## Technical Service Bulletin

#### 35 Gearbox warning light on (DTCs P179E00, P179F00, P0700, P060A)

35 16 22 2032211/4 April 18, 2016. Supersedes Technical Service Bulletin Group 35 number 16-19 dated January 11, 2016 for reasons listed below.

Figure 2. Caution points: drip tray and sensor module connector.

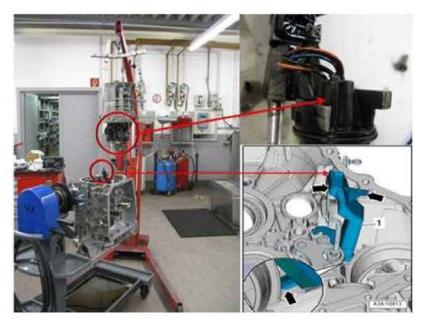
Tip: Use caution when lifting or lowering intermediate housing to avoid damage to components (Figure 2).
